ALERT SERVICE BULLETIN

Service Bulletin No.: DA20-53-02 Rev 0

Title: A-Bolt Washer Size

Figure 1

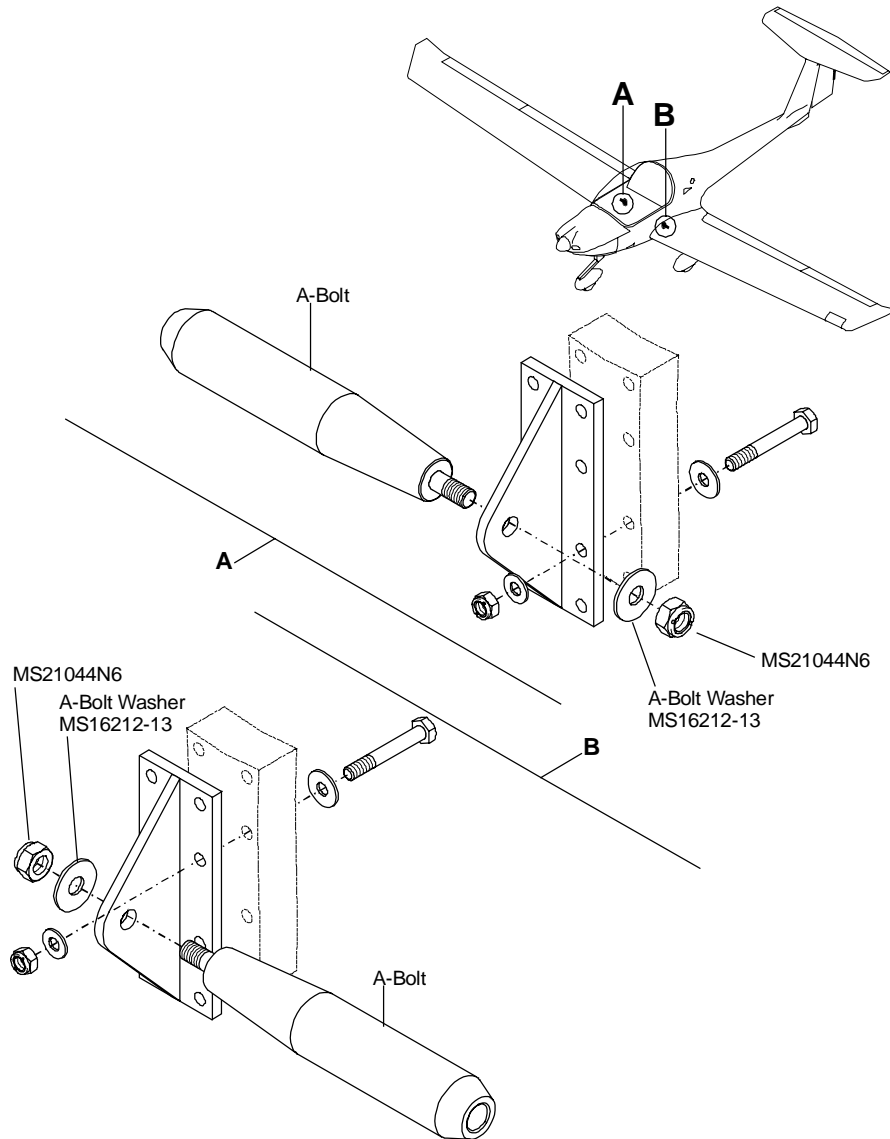
Procure parts listed above locally.
8. **Special Tools:** N/A
9. **References:** DA20 Maintenance Manual, Document number DA201.
10. **Accomplishment Instructions:**
 - 10.1 Remove seats from the aircraft (reference DA201).
 - 10.2 Measure outside diameter of A-Bolt washers.
Correct installation is shown in Figure 1.
 - 10.3 If diameter is not greater than 5/8", remove existing nuts and washers and replace with new washers (P/N MS16212-13) and new nuts (P/N MS21044N6). Torque nuts to 15.4 ft.lbs. (20.8 Nm).
 - 10.4 Reinstall seats (reference DA201).
